THE NATIONAL

BREWERS HILL LOT 6C | BALTIMORE, MD.

UDARP PRESENTATION - SCHEMATIC DESIGN

UDARP COMMENTS + TEAM RESPONSES

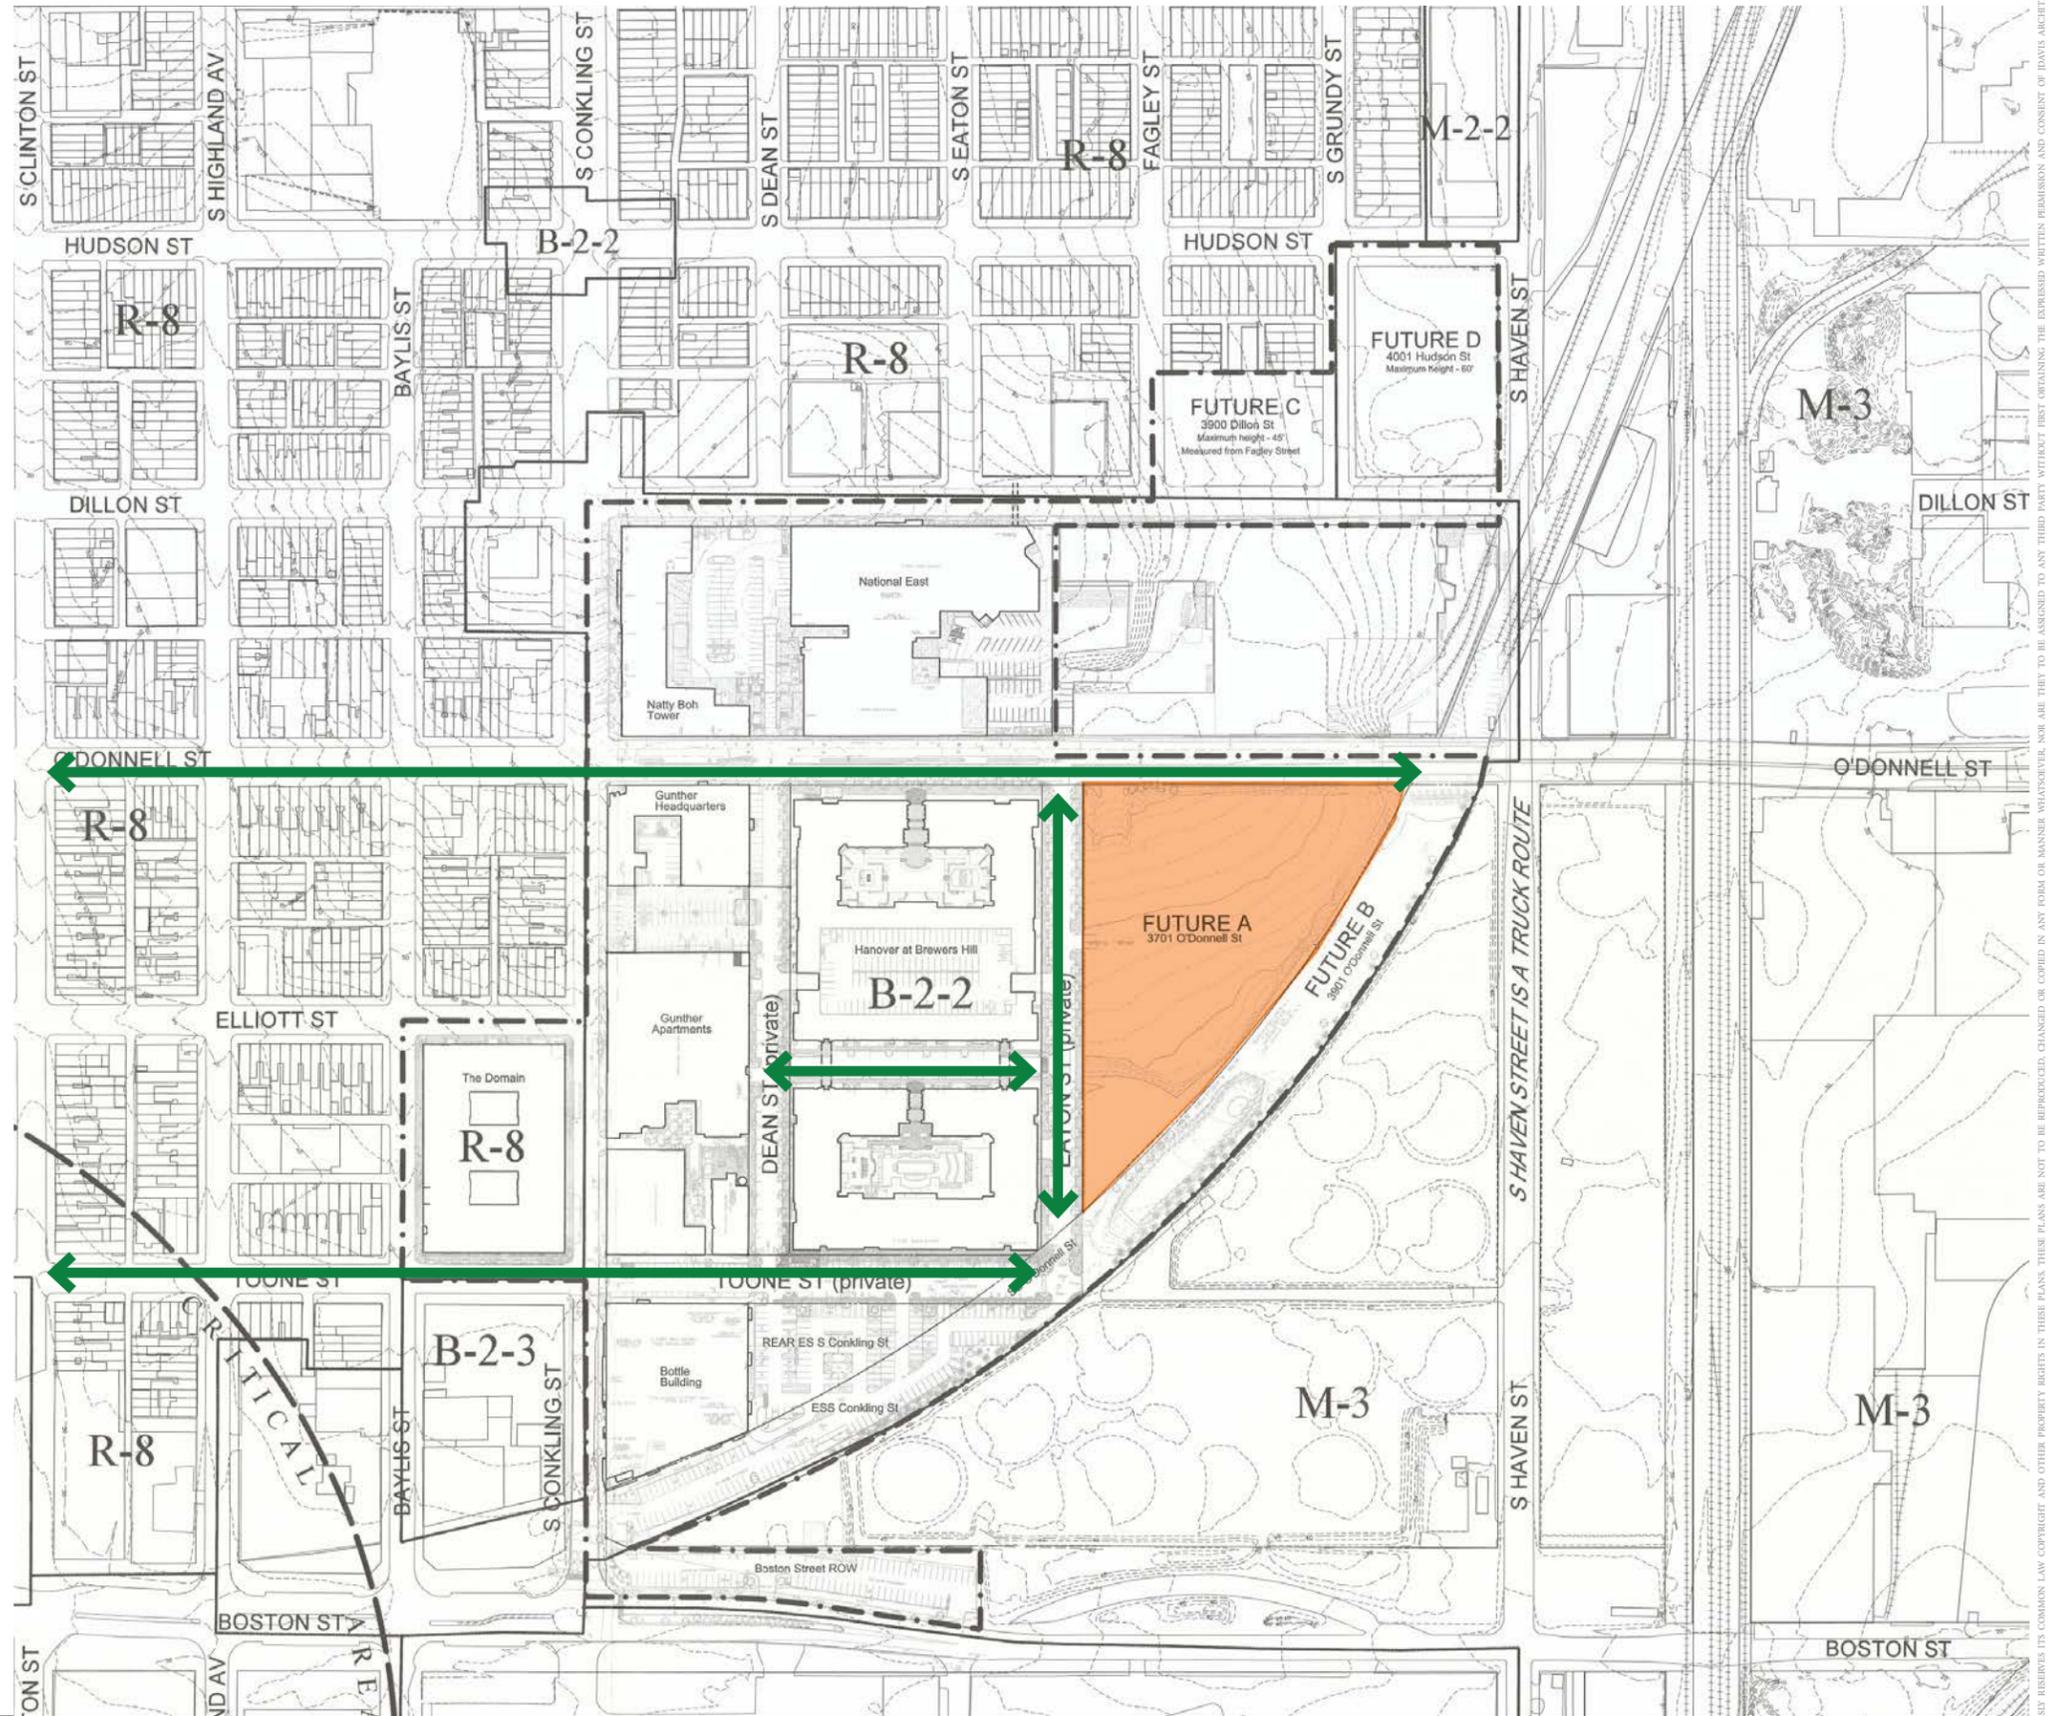
Lack of visual porosity along south facade facing entry plaza. Energize the entry plaza
